WM. H. ZIMMER POWER STATIONINSTRUCTIONS FOR UPDATING YOUR
DESIGN ASSESSMENT REPORT

Changes to the MARK II DAR are identified by a vertical line in the right margin of the page. To update your copy of the ZPS-1 DAR, remove and destroy the following pages and figures and insert pages and figures as indicated.

ZPS-1-MARK II DAR

AMENDMENT 14
APRIL 1981

WM. H. ZIMMER NUCLEAR POWER STATION, UNIT 1
MARK II DESIGN ASSESSMENT REPORT
FIGURE 7.3-4
EMBEDMENT PLATE
(SHEET 1 of 2)

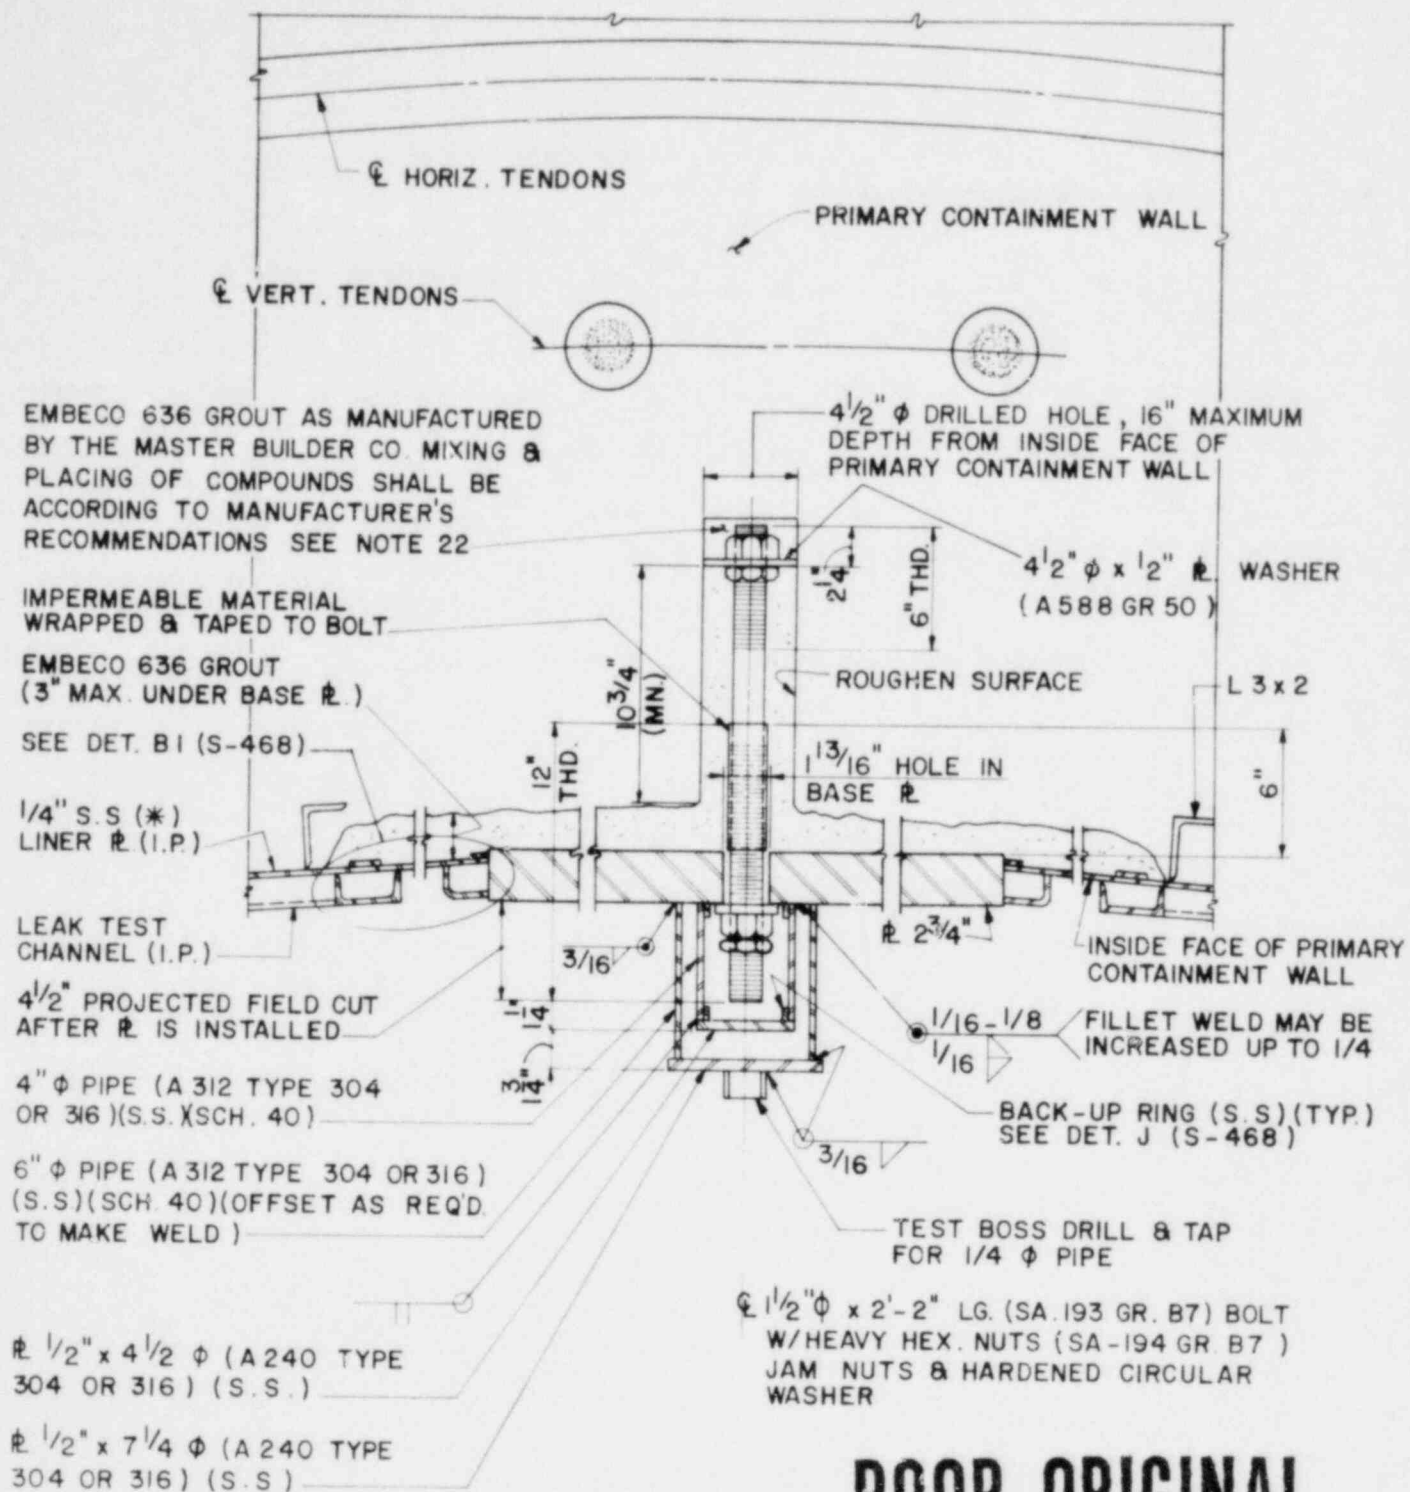
The bracing members are attached to embedment plates which are anchored to the containment wall by a system of bolts and backup cap devices. A typical detail of this attachment is shown in Figure 7.3-4.

As shown in the Figure 7.3-4, the length of the bolt is such that it does not interfere with the vertical or hoop tendons in place. Leak tightness is restored by providing stainless steel pipe caps over the bolts and stainless steel plate inserts around the embedment plate. A typical detail of connection of bracing to downcomer is shown in Figure 7.3-3.

FIGURE 8.2-1

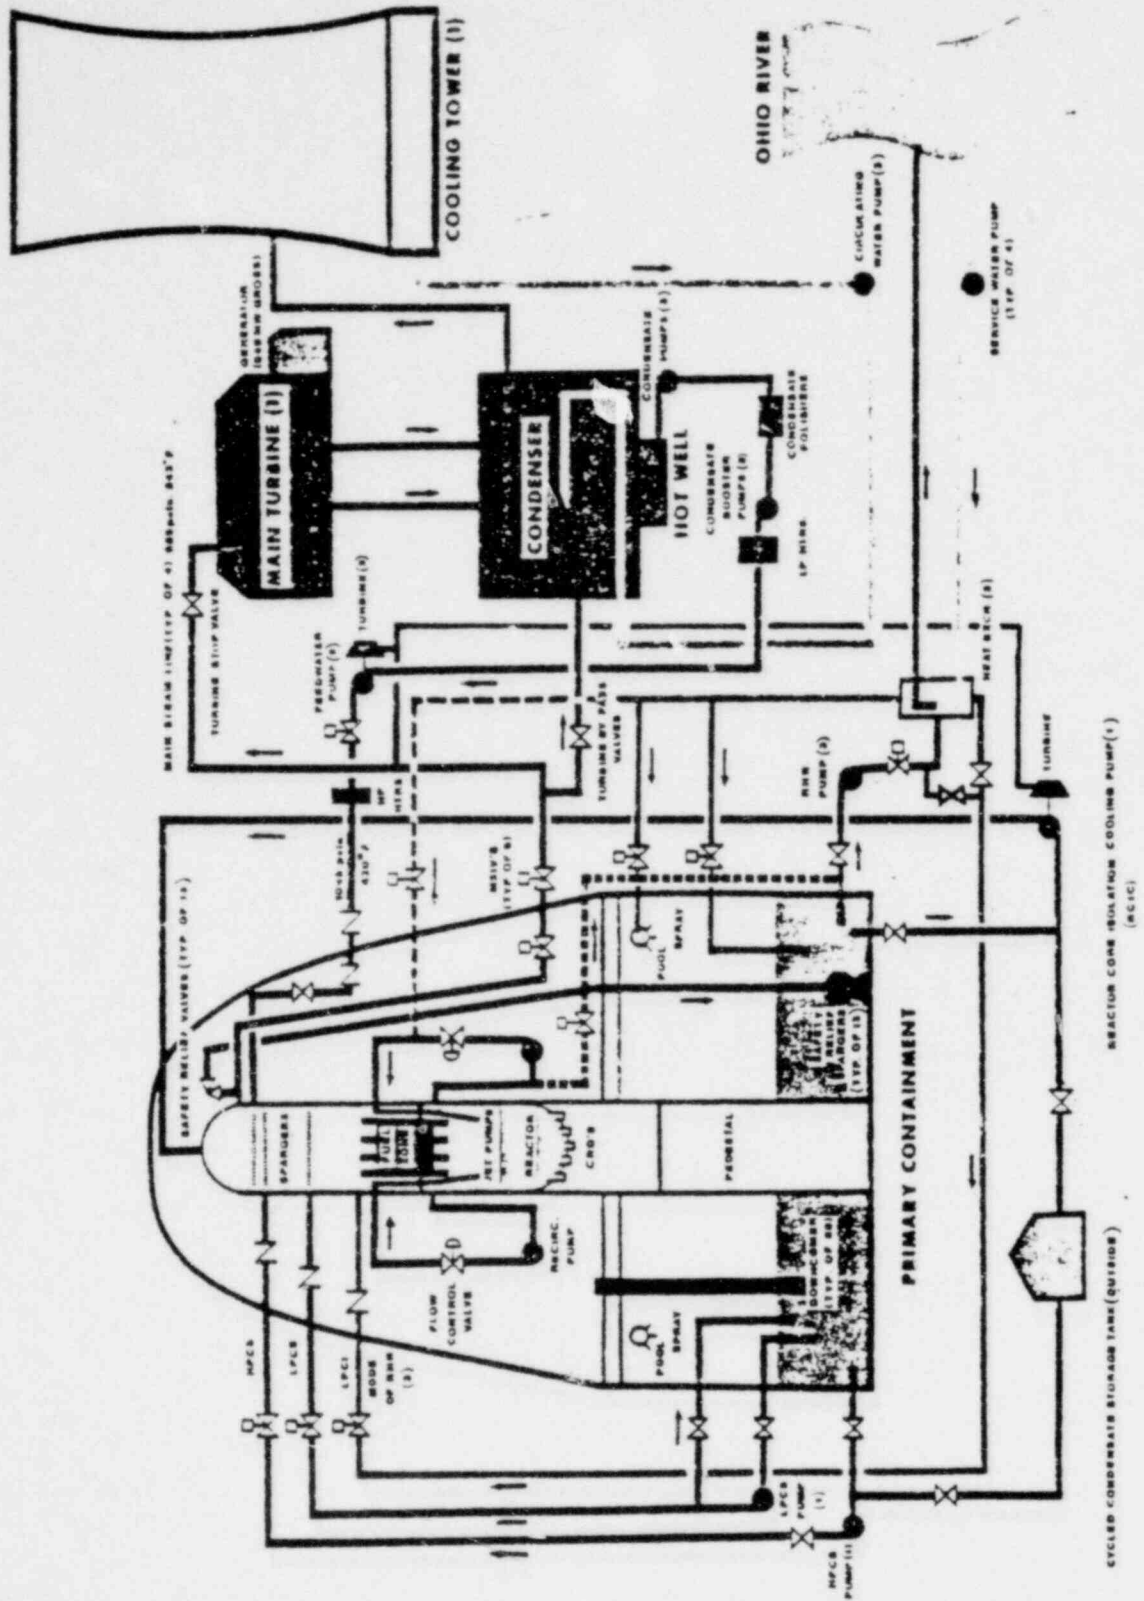
The Wm. H. Zimmer Station Unit 1 (ZPS-1) takes advantage of the large thermal capacitance of the suppression pool during plant transients requiring safety/relief valve (SRV) actuation. The discharged steam is piped from the reactor pressure vessel (RPV) to the suppression pool where it condenses, resulting in a temperature increase of the pool water, but negligible increase in the containment pressure. Most transients that result in relief valve actuations are of very short duration and have a small effect on the suppression pool temperature. However, certain postulated events with conservative assumptions present the potential for substantial energy additions to the suppression pool that could result in high pool temperature. See Figure 8.2-1 for a graphical representation.

WM. H. ZIMMER NUCLEAR POWER STATION, UNIT 1
MARK II DESIGN ASSESSMENT REPORT
FIGURE 8.2-2
RESIDUAL HEAT REMOVAL SYSTEM

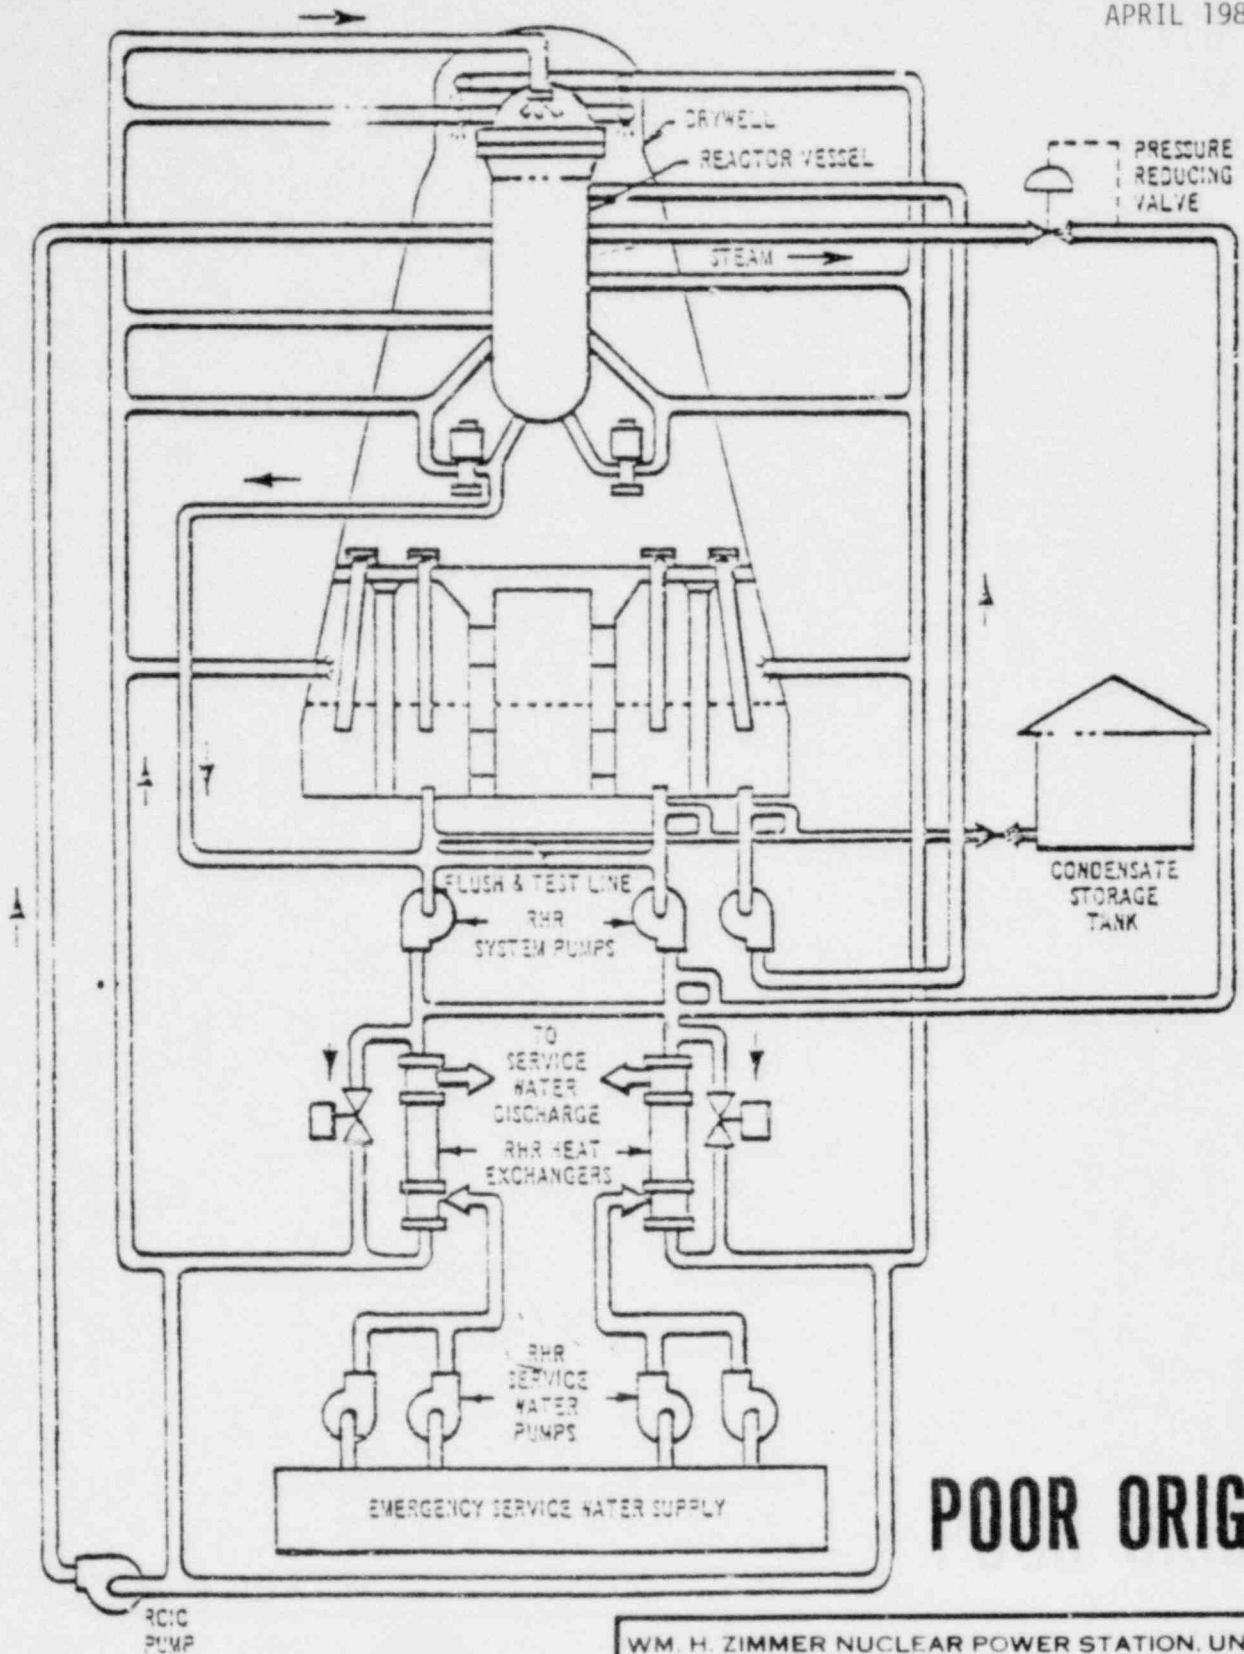
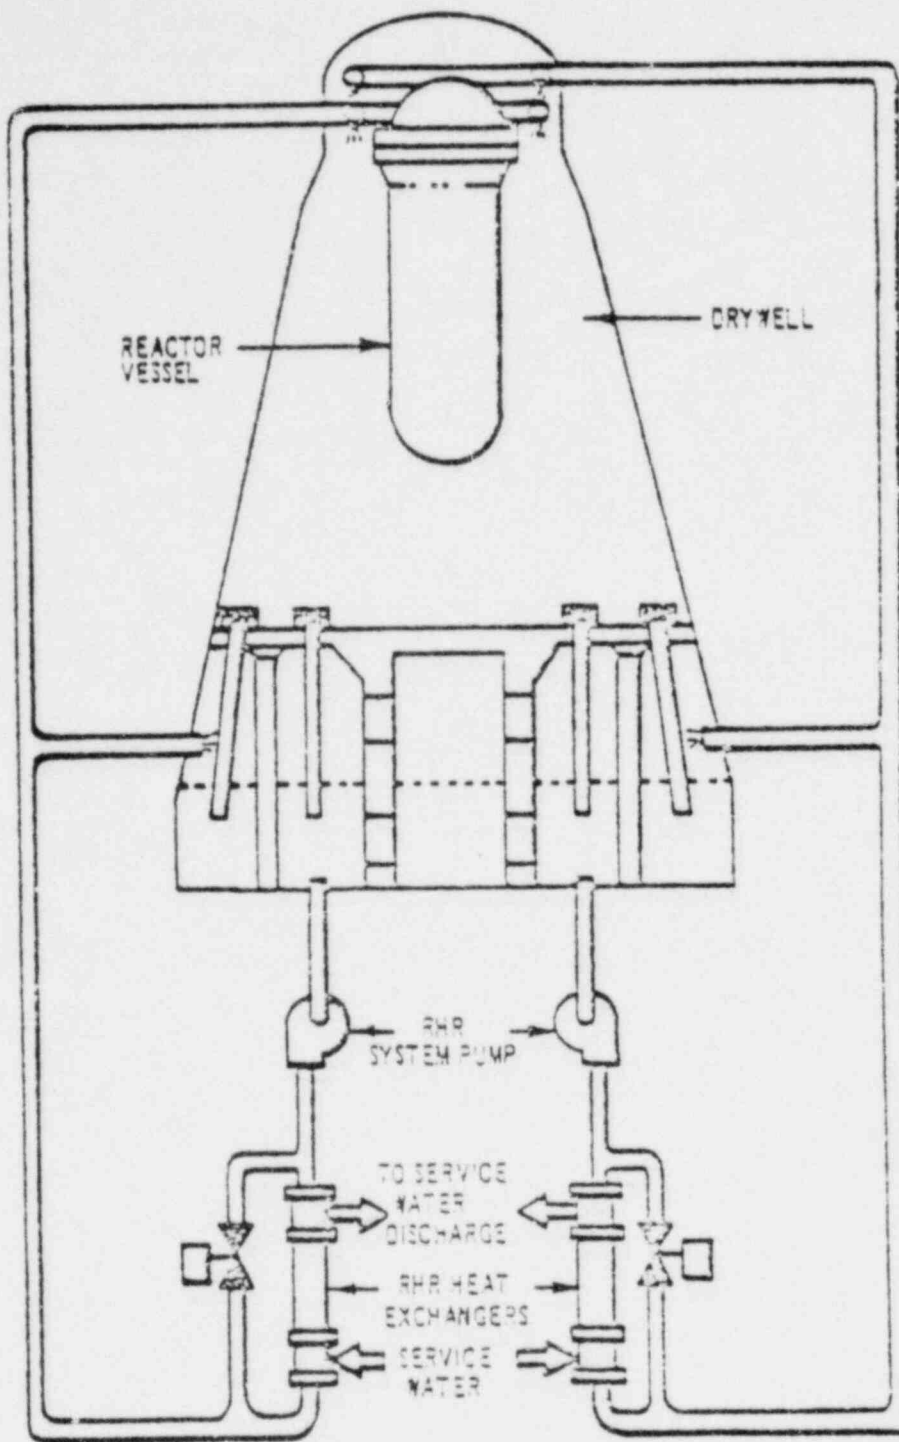
ZPS-1 uses the residual heat removal (RHR) system to remove heat from the suppression pool. The RHR system consists of three independent loops. Two of these loops are equipped with 100% capacity heat exchangers that are available in the pool cooling, shutdown cooling, containment spray, and steam condensing modes of operation. The RHR heat exchangers are U-tube, vertical head-down units which use Ohio River water for tube side coolant. All three RHR loops are available for the low pressure coolant injection (LPCI) mode of operation. See Figures 8.2-2 through 8.2-6 for a graphical representation of the RHR system.

WM. H. ZIMMER NUCLEAR POWER STATION, UNIT 1
MARK II DESIGN ASSESSMENT REPORT
FIGURE 8.2-7
FEEDWATER SYSTEM (FW)

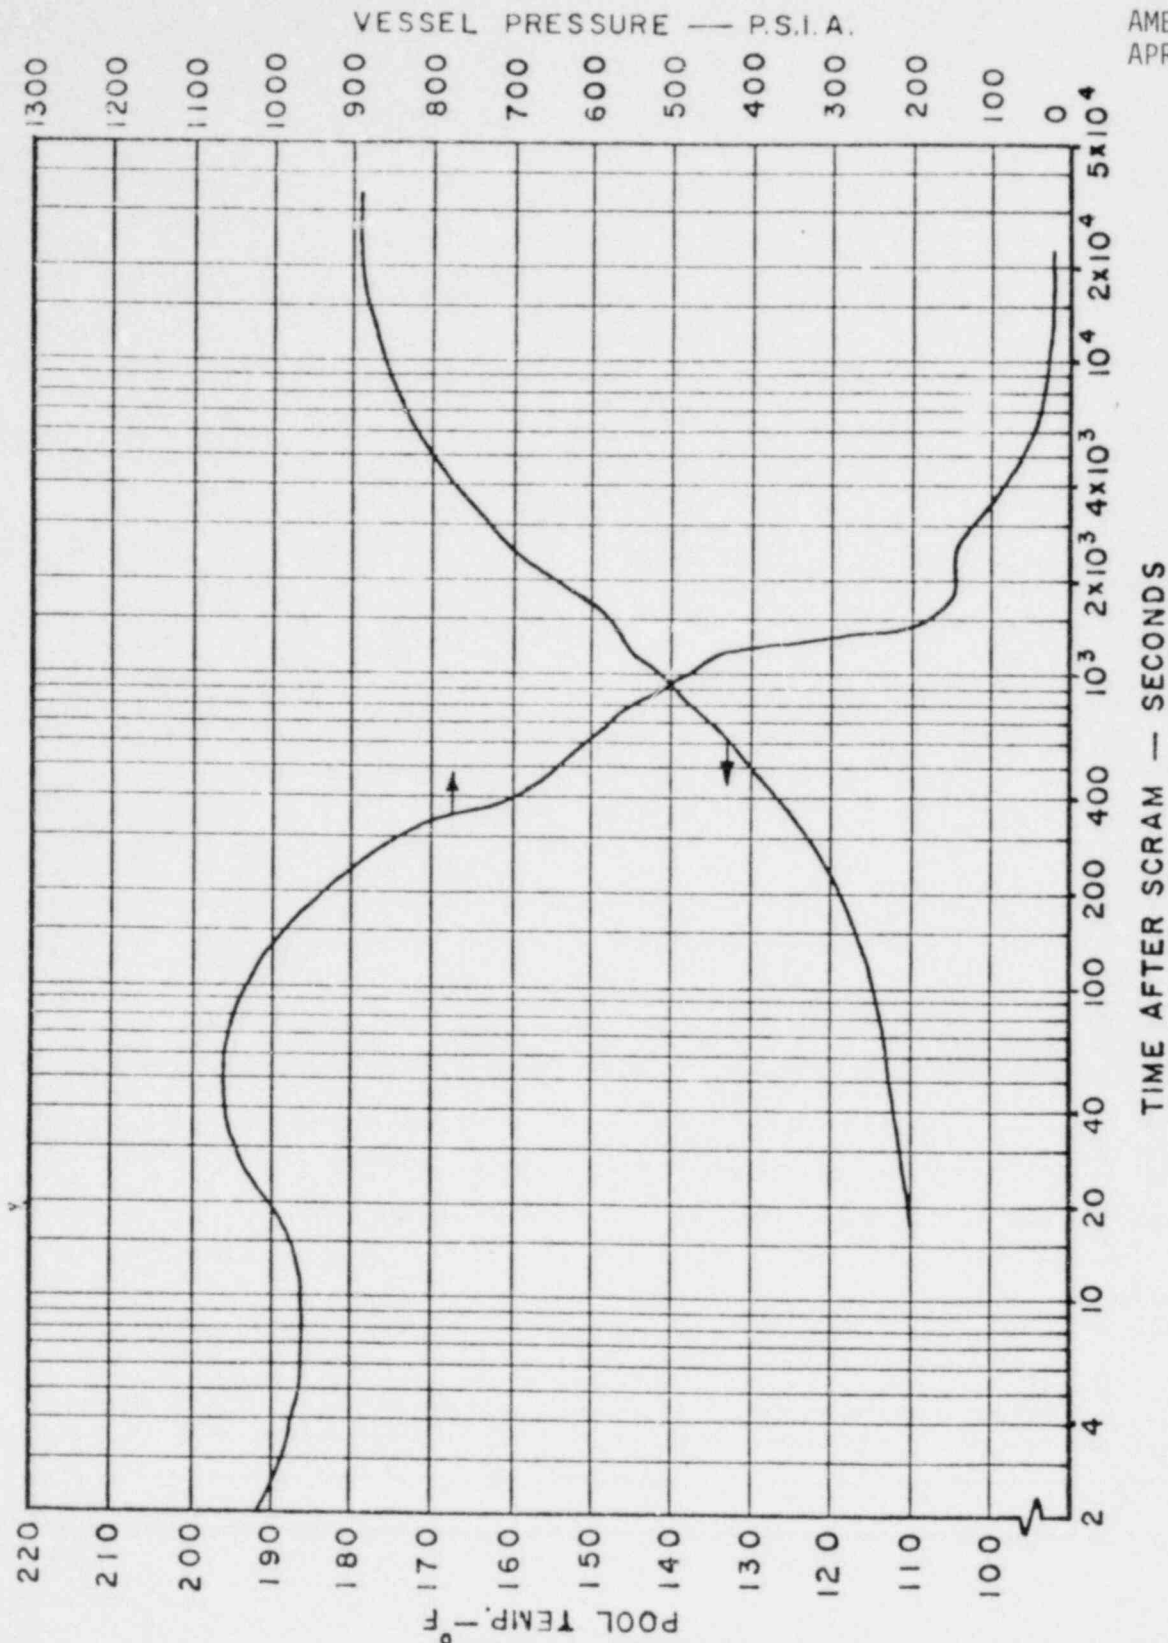
ZPS-1 is equipped with two steam-driven feedwater pump turbines (Figure 8.2-7) which receive their steam supply from the main steamlines downstream from the main steam isolation valves (MSIV's). When MSIV closure occurs, the steam driving force to the feedwater turbines is eliminated, causing a rapid decrease in the amount of feedwater entering the RPV. This treatment of the feedwater system is not used in this analysis. ZPS-1 feedwater system is described in Subsection 10.4.7 of the ZPS-1 FSAR.
